NEW MIXED-USE OFFICE, RETAIL/COMMERCIAL AND RESIDENTIAL BUILDING

REVISIONS TO PROJECT PER COMMISSION OF ARCHITECTURAL REVIEW COMMENTS AND CONDITIONS 17/05.09

2411 M ST
[JEFFERSON AVE/M ST/24TH ST]
RICHMOND, VA
23223

ARCHITECTURAL SITE PLAN & PROJECT INFORMATION

01 3RD LEVEL/RESIDENTIAL

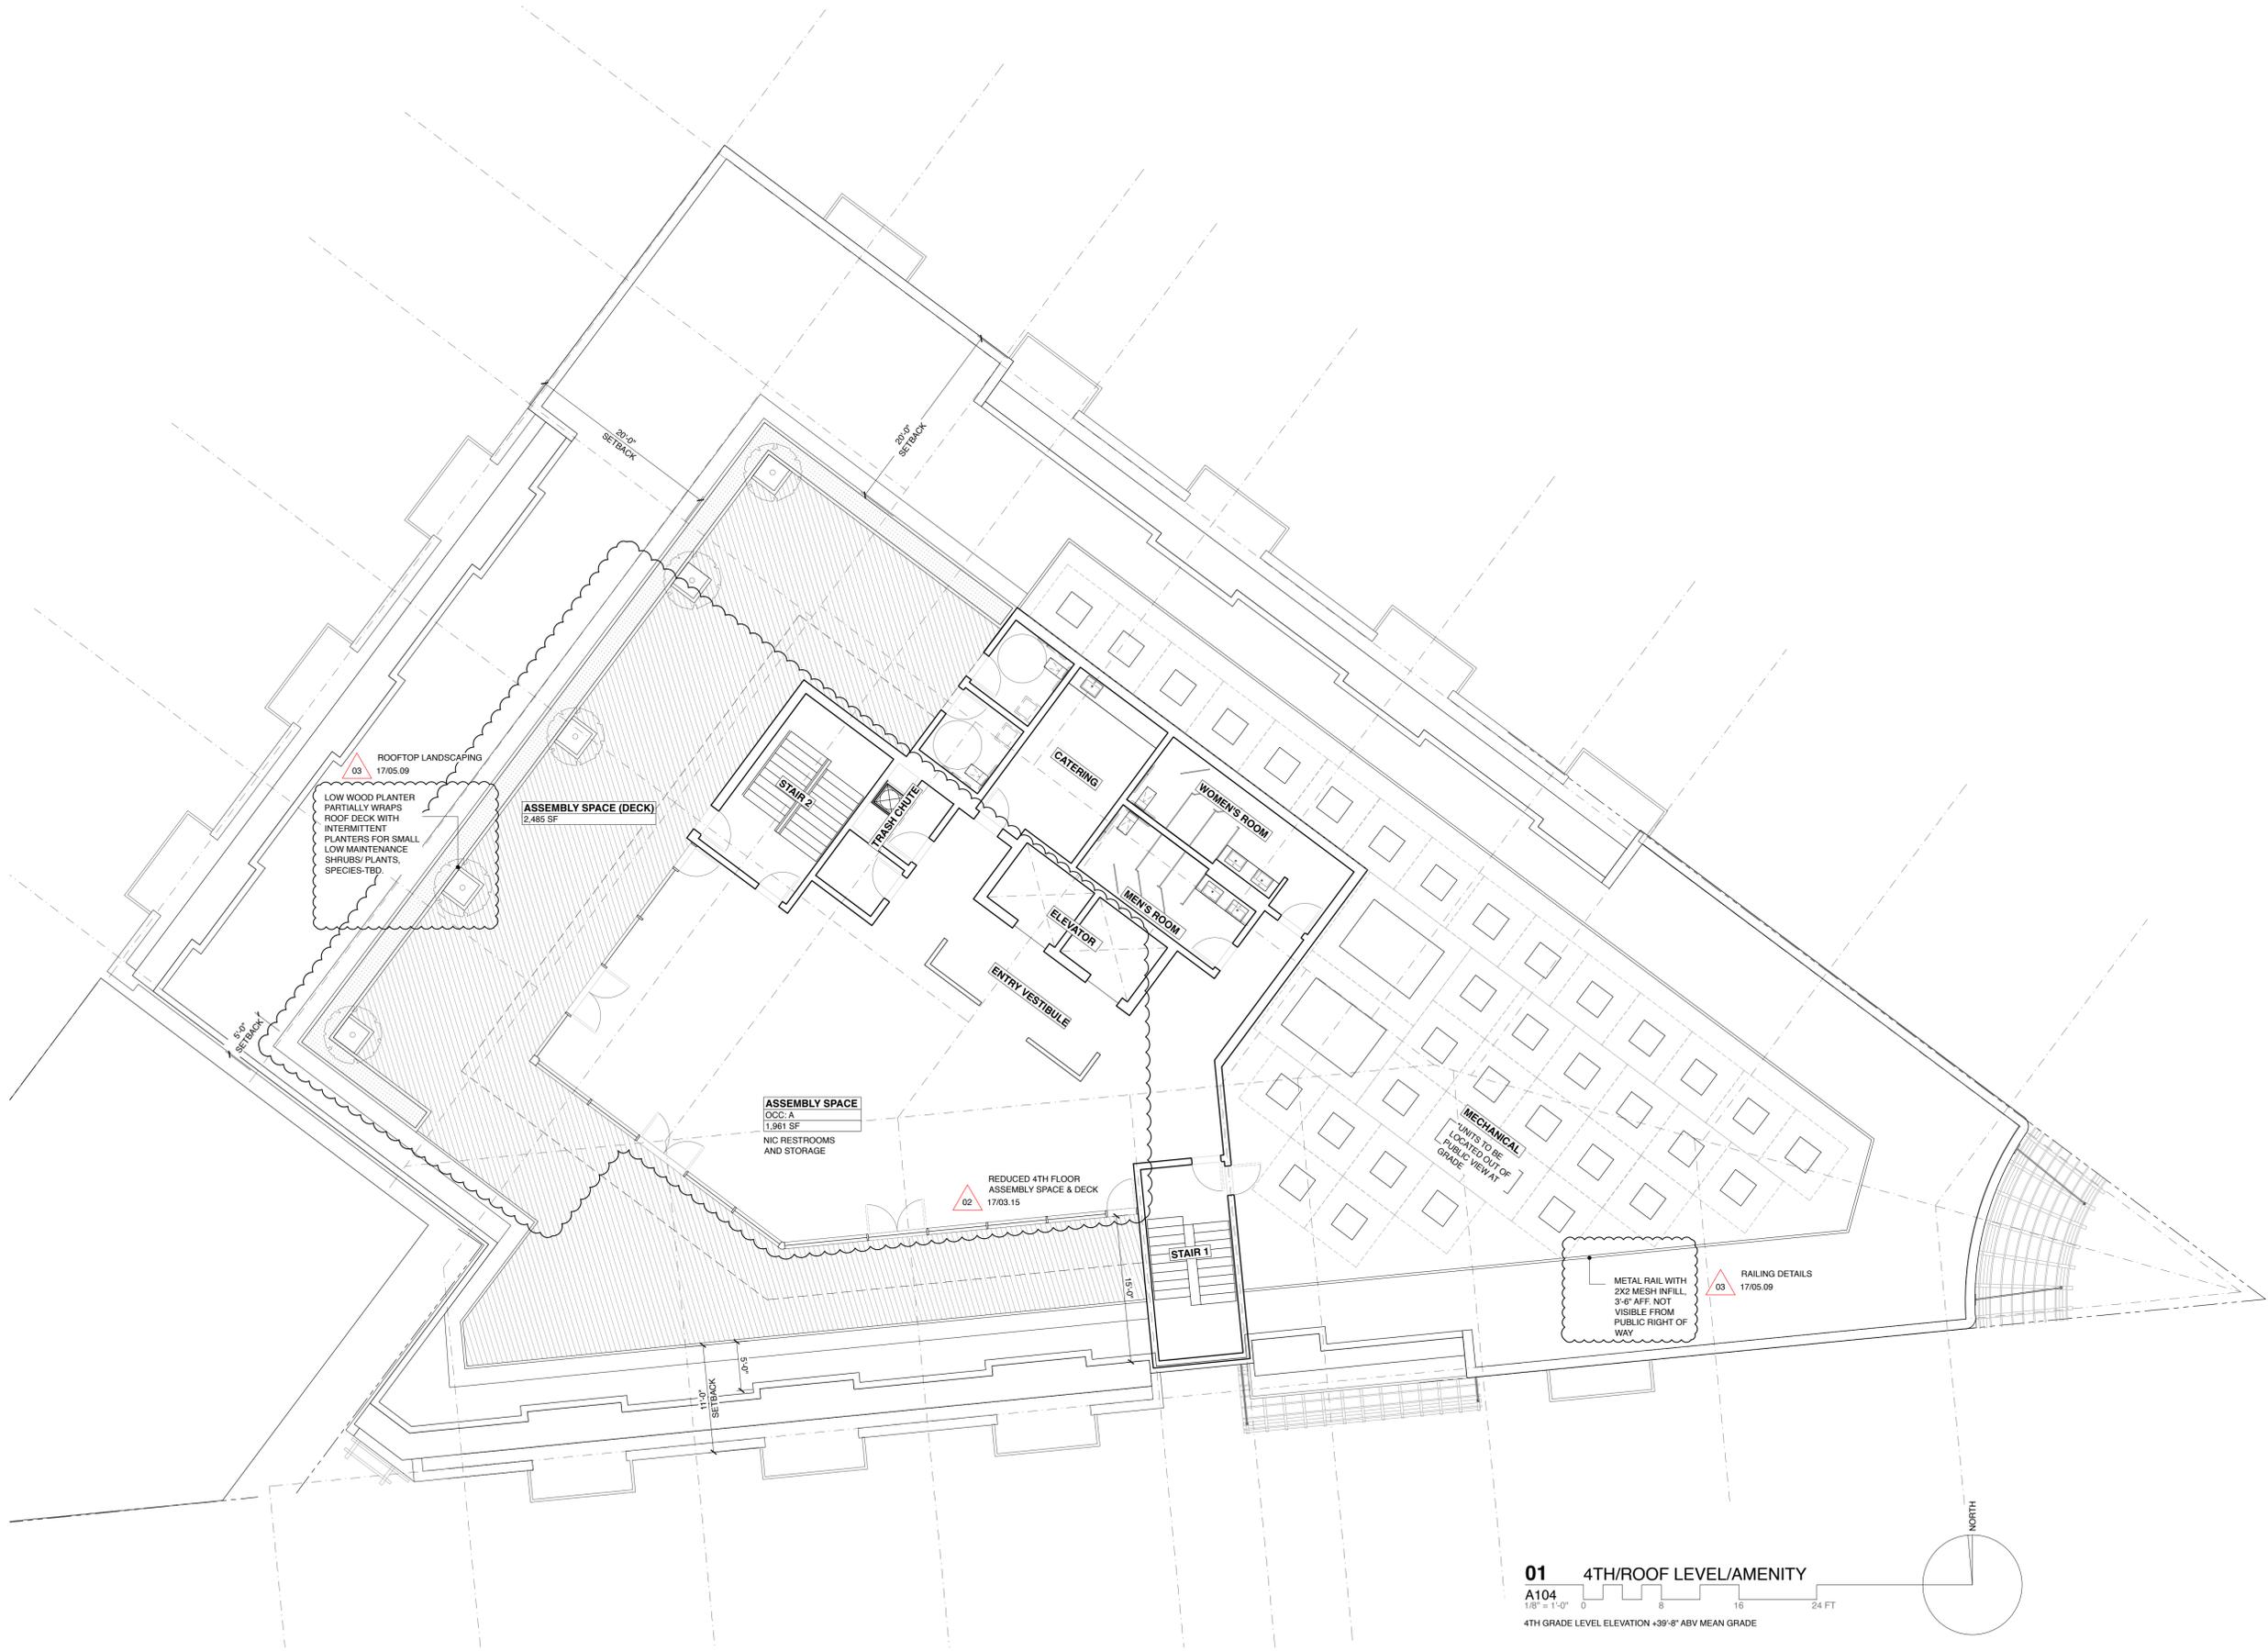
UPDATED PLAN/ELEVATION - FULL HT
BRICK AT JEFFERSON/ M ST
17/03/15

01 3RD LEVEL ENLARGED UNIT PLANS

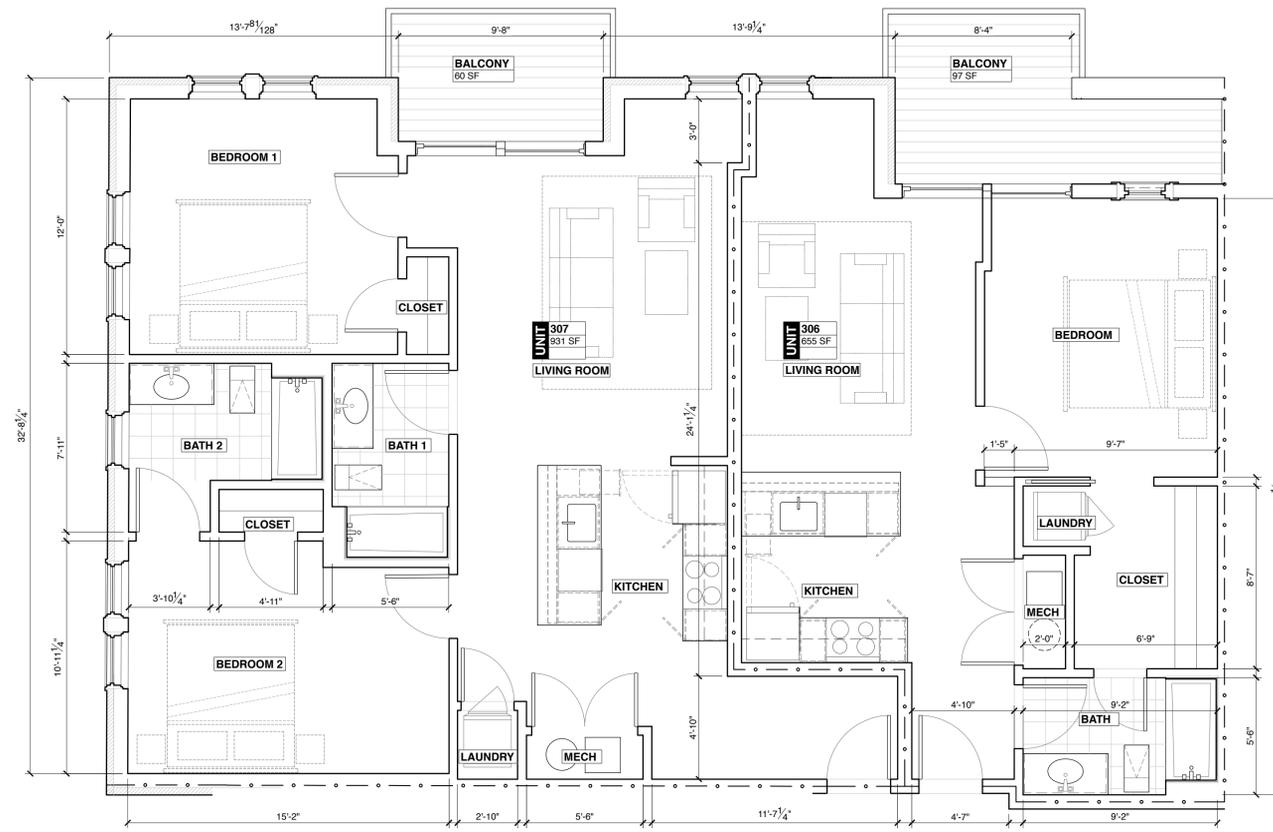
UPDATED PLAN/ELEVATION - FULL HT BRICK AT JEFFERSON/M ST 17/03/15
